Serial No. 10-063A
LIC/JG/R0
Docket No. 50-305
License No. DPR-43

DOMINION ENERGY KEWAUNEE, INC.
KEWAUNEE POWER STATION
SUPPLEMENT AND RESPONSE TO REQUEST FOR ADDITIONAL INFORMATION:
LICENSE AMENDMENT REQUEST 236, AUTOMATIC OPERATION OF
TRANSFORMER LOAD TAP CHANGERS (TAC NO. ME4011)

**RESPONSE TO REQUEST FOR ADDITIONAL INFORMATION:
LICENSE AMENDMENT REQUEST 236
AUTOMATIC OPERATION OF TRANSFORMER LOAD TAP CHANGERS**

Figure 1

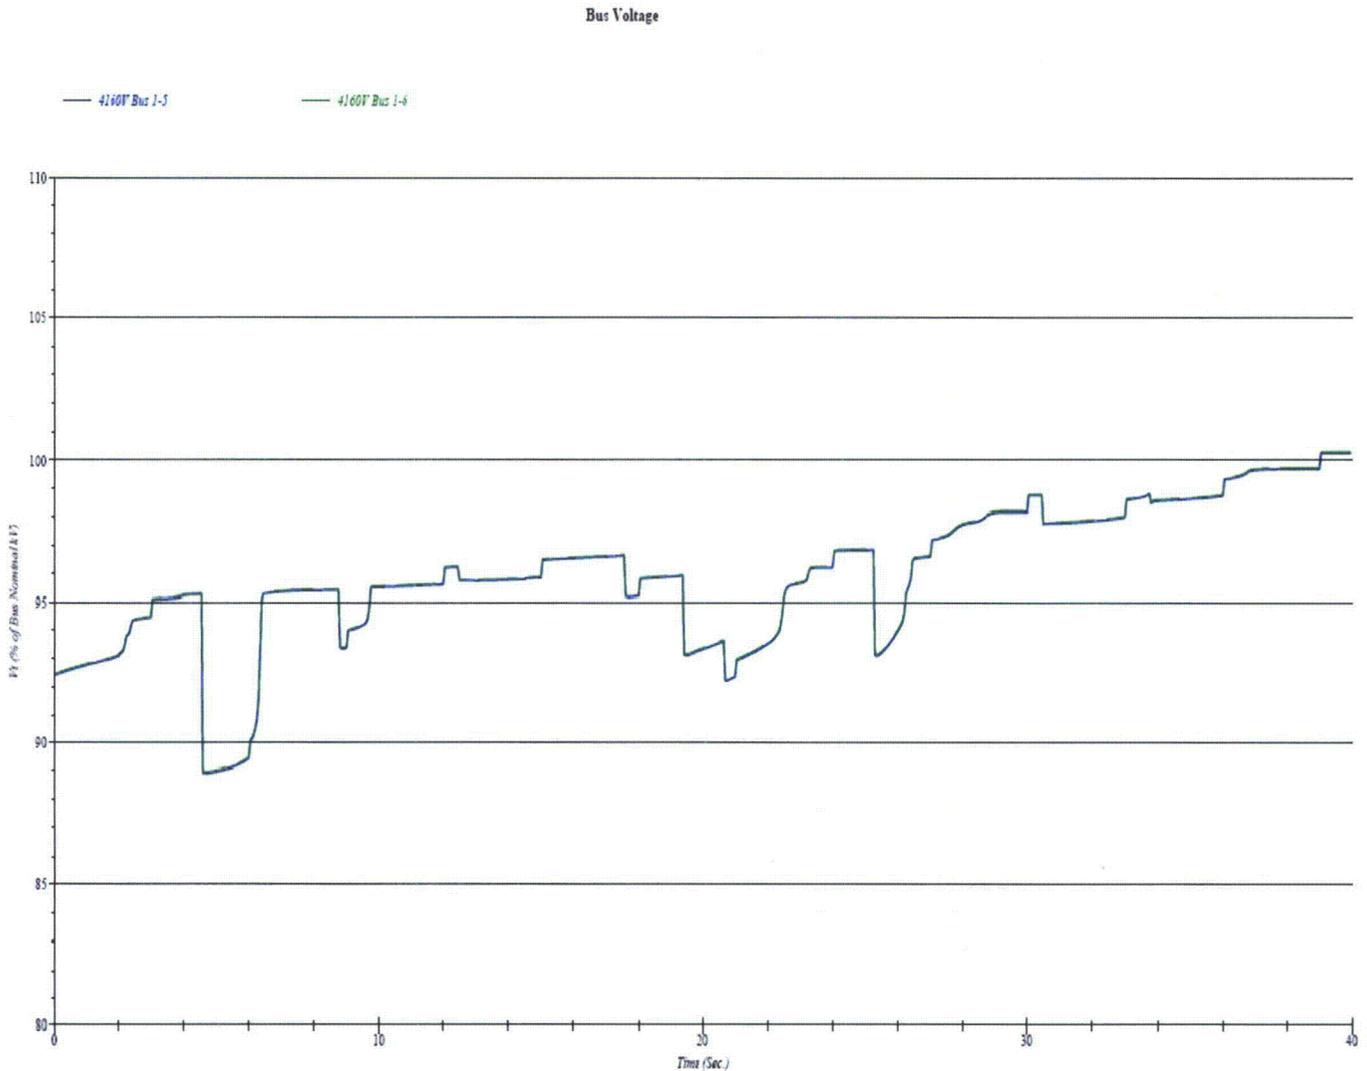
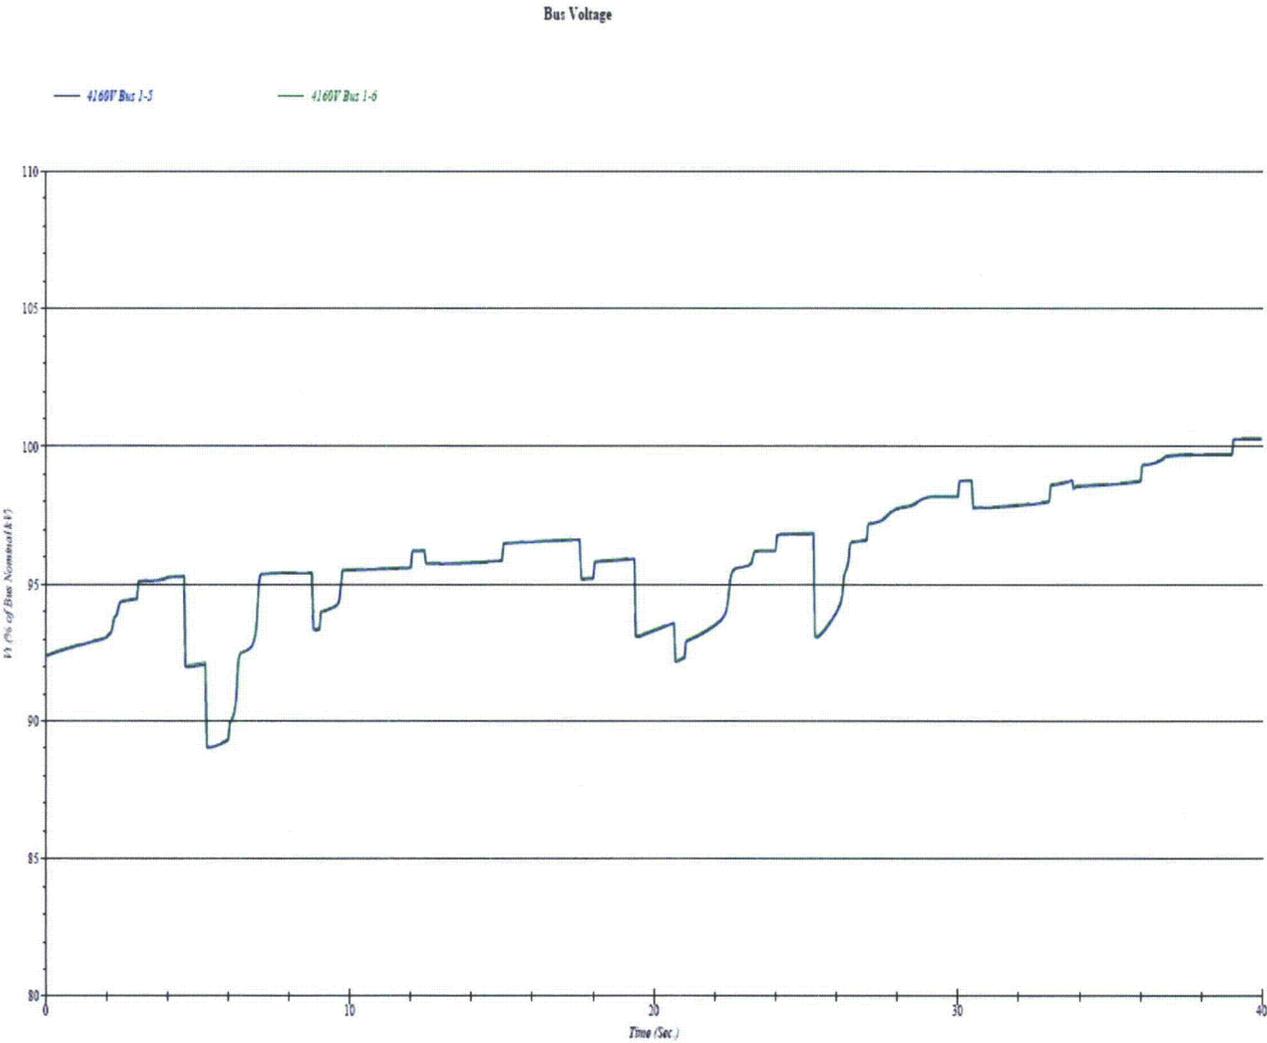
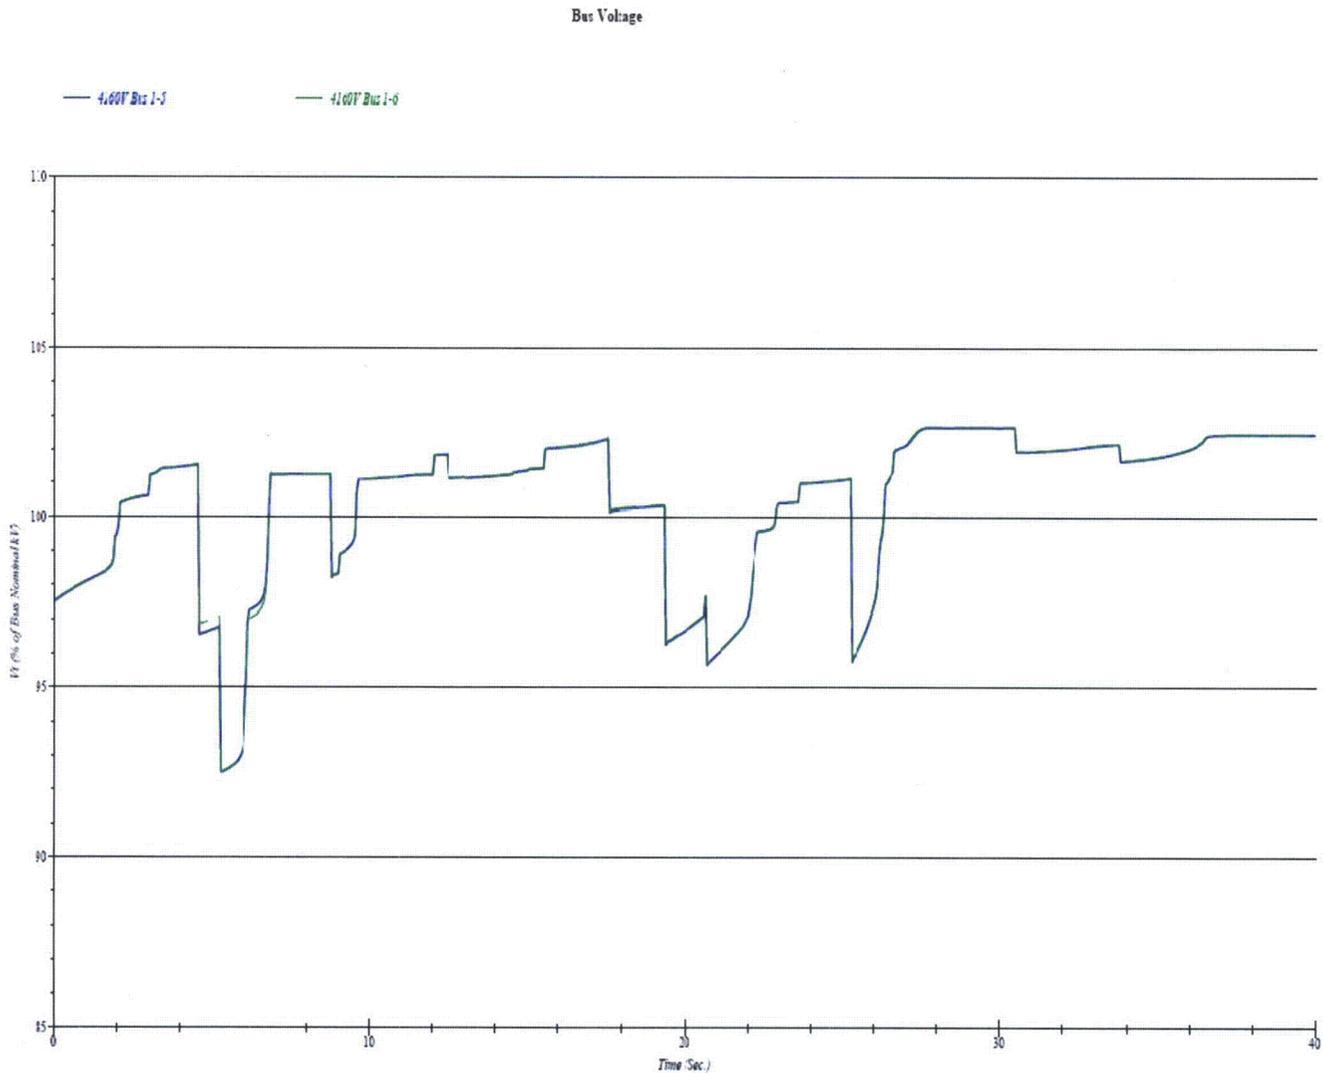
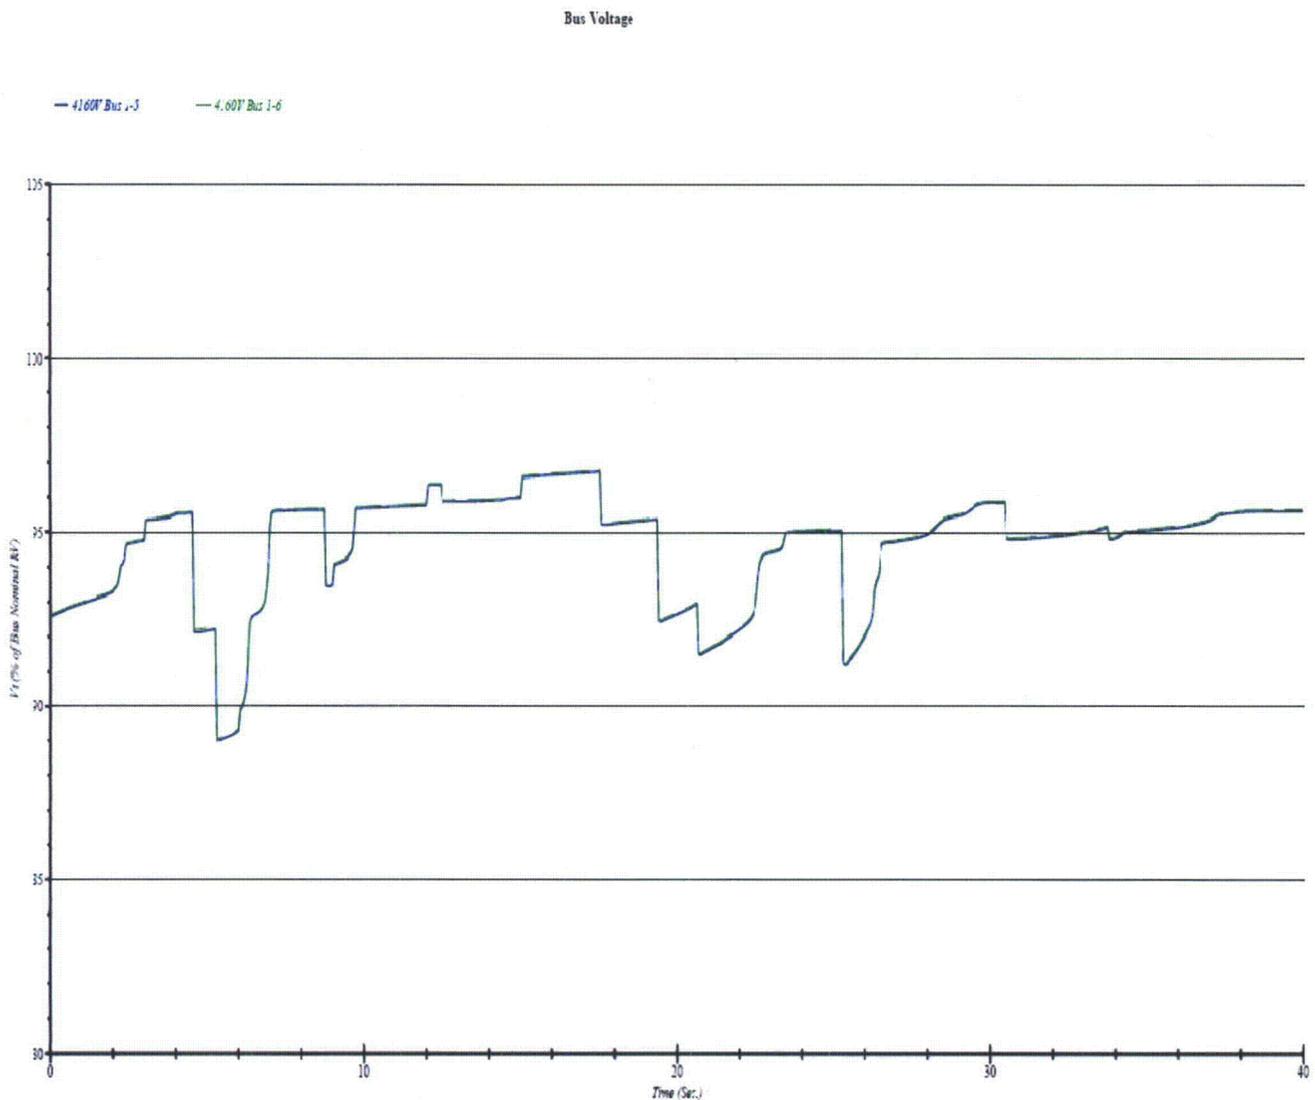
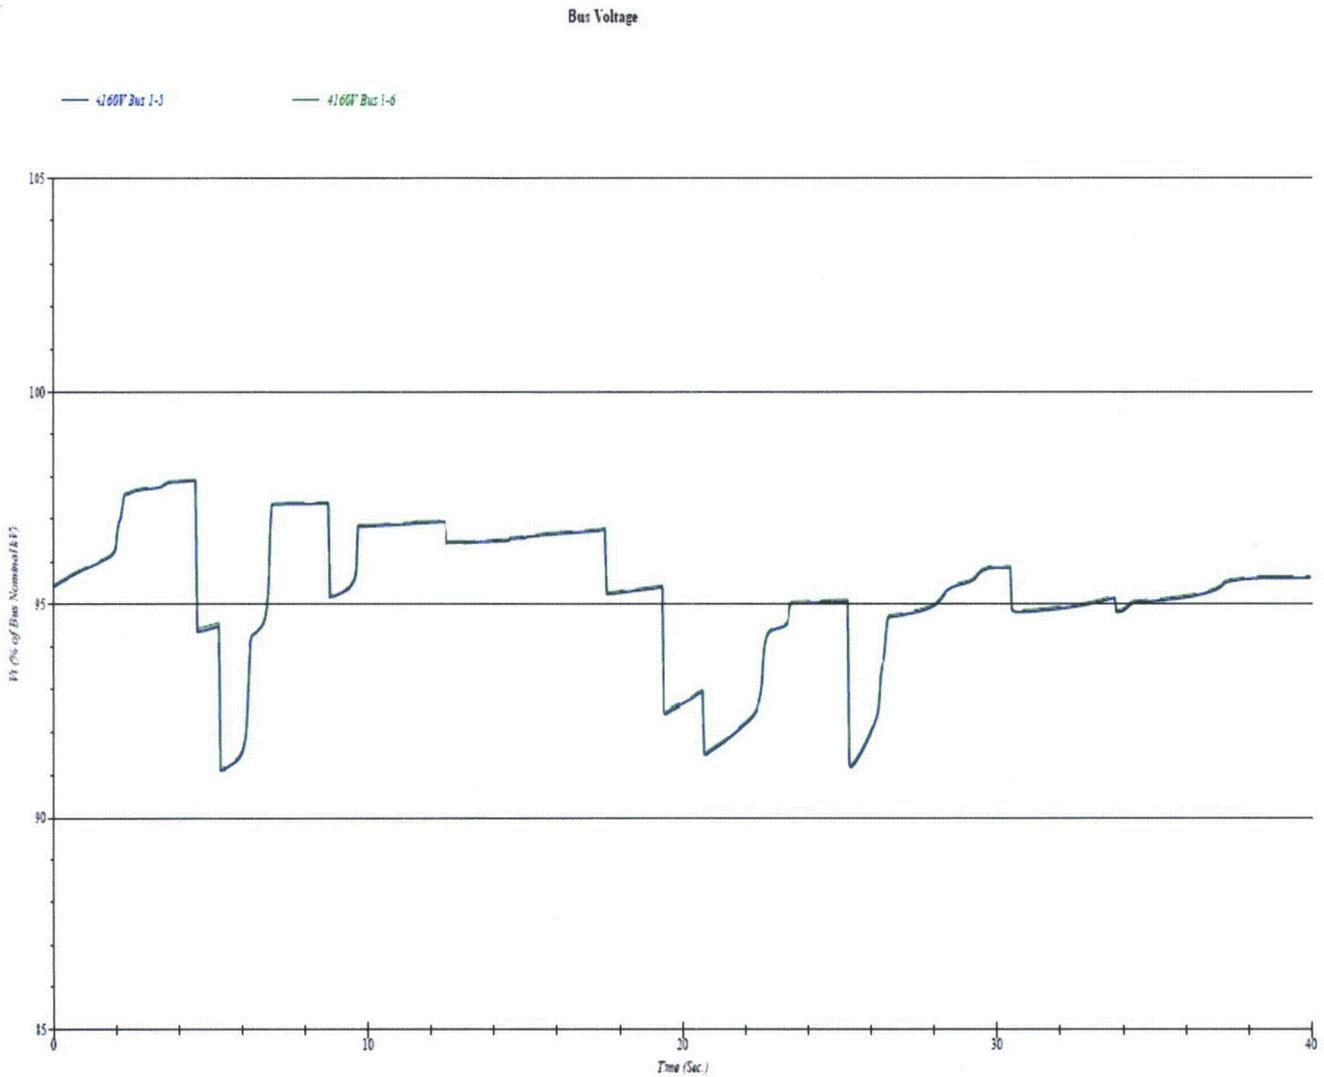
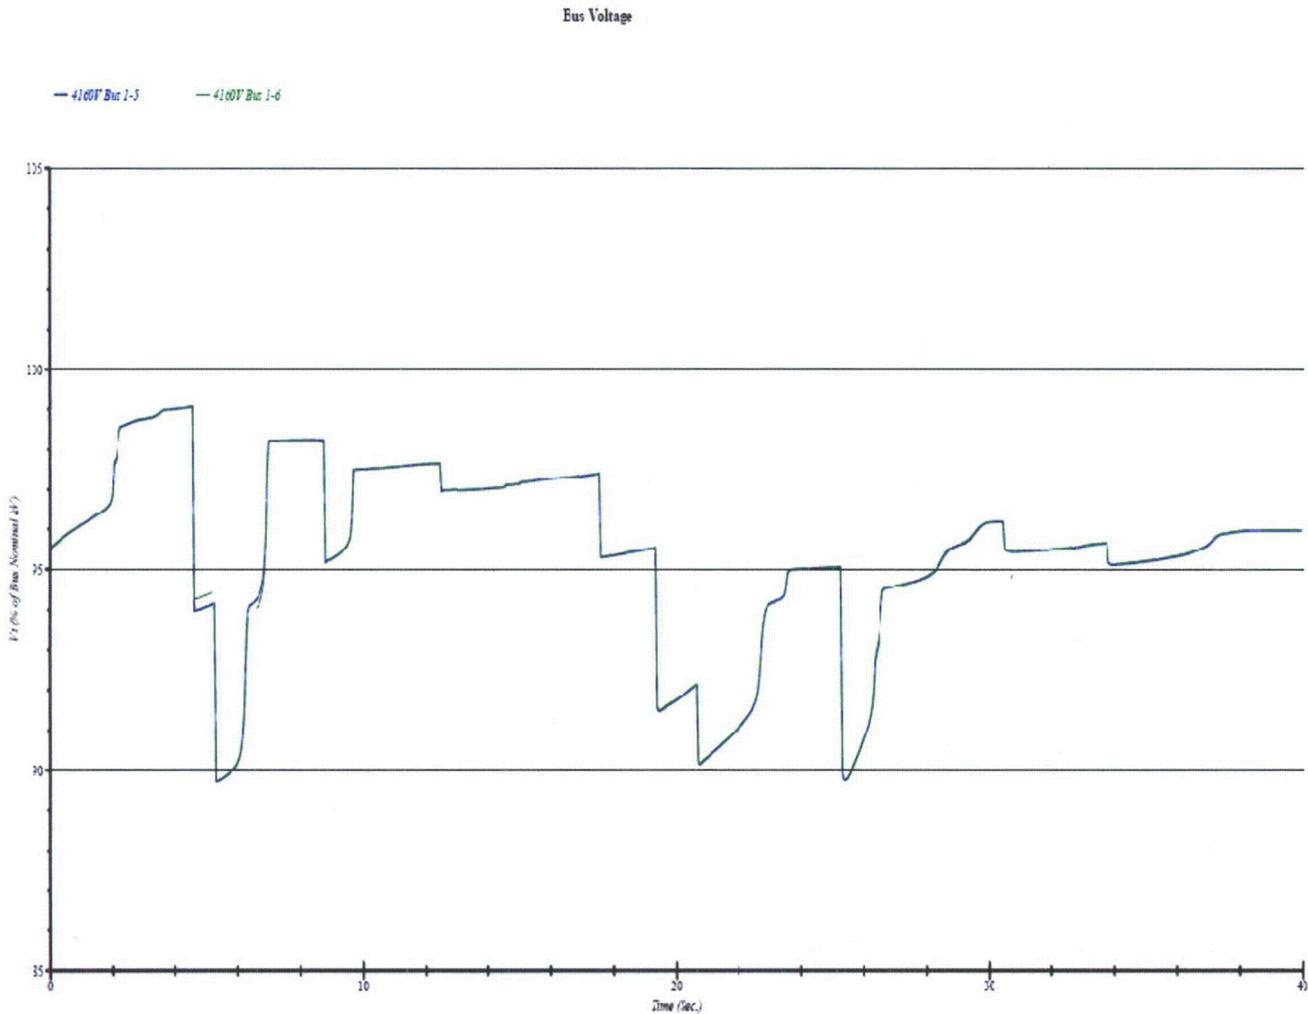
Bus 1-5 is normally supplied from the TAT and Bus 1-6 is normally supplied from the RAT. Thus, no bus transfer is required for the engineered safety features in the event of a unit trip. The plant was designed with an automatic bus transfer feature. Verify that a single failure of the bus transfer scheme will not result in transfer of the Busses 1-5 and 1-6 to a single source of offsite source during a design basis event.

ETAP runs were performed to verify the initial tap position (post event) based on the pre-event tap position (prior to generator trip and SI sequence initiation); and, to establish that the degraded voltage relaying (DVR) would not actuate. Based on analyses performed by American Transmission Company (ATC – transmission operator for KPS), if KPS loses both of its 345kV lines or both T10 and T20 345/138kV transformers (related to the two 345kV switchyard lines); or, if both Point Beach Nuclear Power (PBNP) units are unavailable; or, if Q303 (345kV) and F84 (138kV) transmission lines are both out of service, then it is possible that the maximum change in switchyard voltage due to a KPS unit trip would be from 1.82% to 2.76%. Therefore, for the above

Absence of these worst case conditions would result in a much smaller resultant voltage change. The ATC analyses show that other possible limiting switchyard configurations would result in a maximum voltage drop of 1.465% or less. DEK plans to request that ATC provide a programmed load/voltage forecast warning indication to KPS upon the system forecasting a 1.46% or larger drop in voltage at KPS (due to KPS unit trip). In the event that a larger than 1.46% drop in voltage is forecasted, KPS operators have the capability to manually transfer Buses 1-3 and/or 1-4 to the RAT. This anticipatory transfer would cause the upstream RAT supply transformer (RST) LTC to raise taps and account for the additional Bus 1-3 and/or Bus 1-4 load prior to the trip and thereby decrease the 4kV voltage drop associated with the non-safety related bus transfer at the time of a unit trip. Thus, DVR actuation would not be expected to occur, and the offsite power source (RAT supply) would be maintained.

Voltage profile graphs of the associated ETAP analyses results are provided (for information) in Figures 1 through 7 below. These graphs show that voltage does not decrease below 95% of nominal bus voltage for more than 6 seconds. Although the DVRs themselves actuate, their associated time delay relays do not time out. Thus, no bus stripping signal is initiated and offsite power remains available.
